ADDENDUM#1

BID NUMBER: UCA-27-034
OPENING DATE: October 22, 2026
OPENING TIME: 9:00 a.m.
PROJECT: Pressure Washing Services

Attachment 7

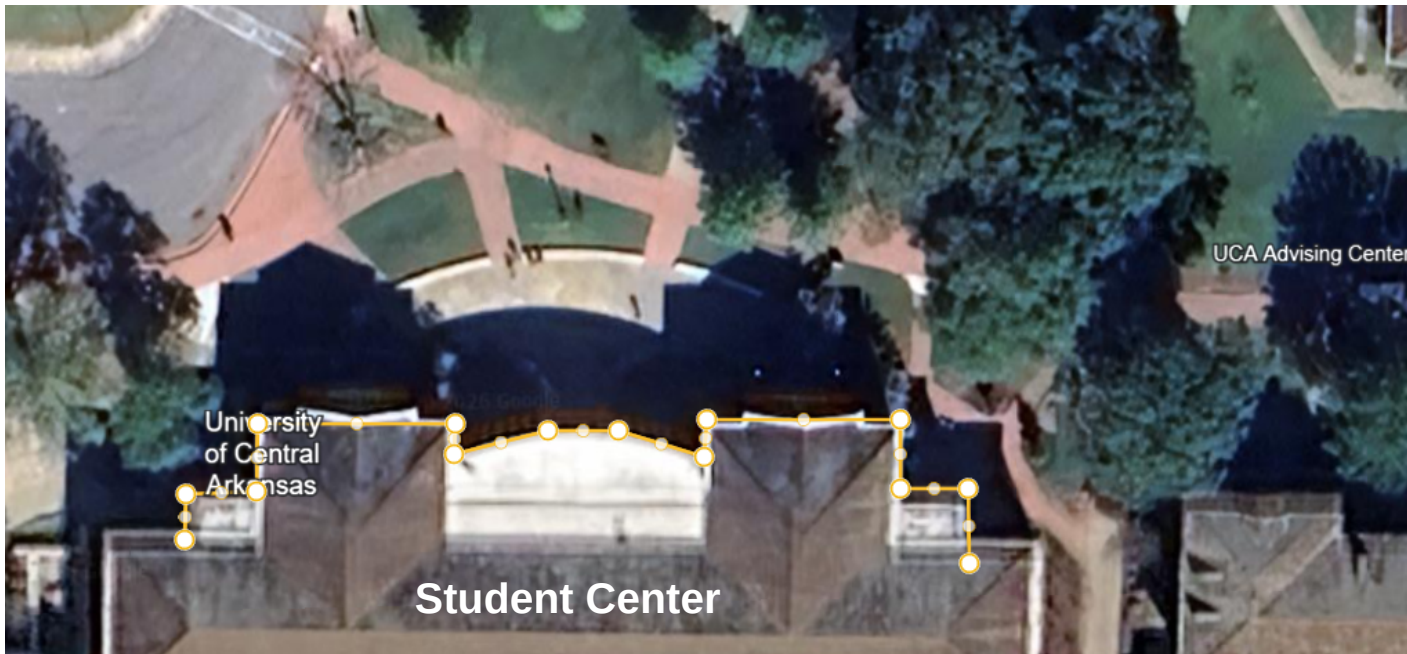
Base price on
2,400sqft windows
1,200sqft porch ceiling & surrounding soffit
4 x 40' tall columns
60' wide gable

Base price on on 30' height
Approximately 9,630sqft
Windows should be priced as
softwashing or squeegeeing
